Automated ankle brachial pressure index measurement devices for assessing peripheral arterial disease in people with leg ulceration

Diagnostics Assessment Report (DAR) - Comments

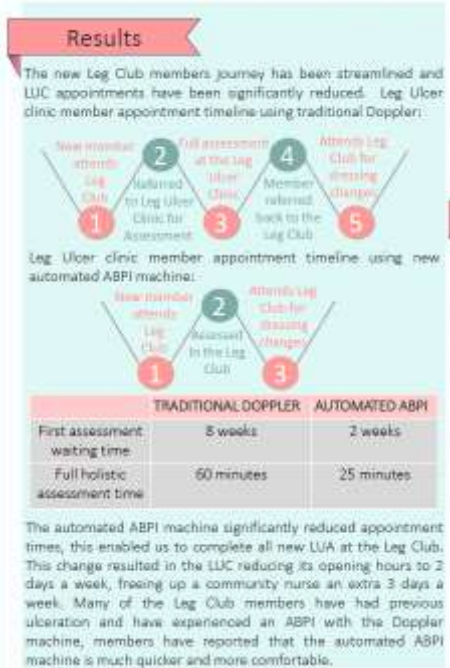
Stakeholder	Comment no.	Page no.	Section no.	Comment	EAG Response
MESI	26		54	<p>P54: The report states that there is a (direct citation) “<i>systematic tendency for the automated device to overestimate ABPI values with larger differences observed in the lower range of ABPI values</i>”. In such cases, MESI ABPI MD and MESI mTABLET ABI have a significant advantage: the presence of an entire pulse waveform and oscillation graph for the entirety of the deflation portion. From the oscillation graph, the clinician can determine whether the arteries were elastic (i.e., responded to being briefly compressed) or not. The pulse waveforms provide an assessment of the presence or absence of clearly pronounced pulses with clear dicrotic notch:</p>  <p><i>Figure 1: Healthy waveforms obtained with MESI mTABLET ABI measurement</i></p>	<p>Please note that we have not identified any published study assessing the performance of MESI mTABLET ABI. The included studies assessing the performance of MESI ABPI MD as well as other relevant devices reported a tendency for the automated device to overestimate ABPI values.</p>
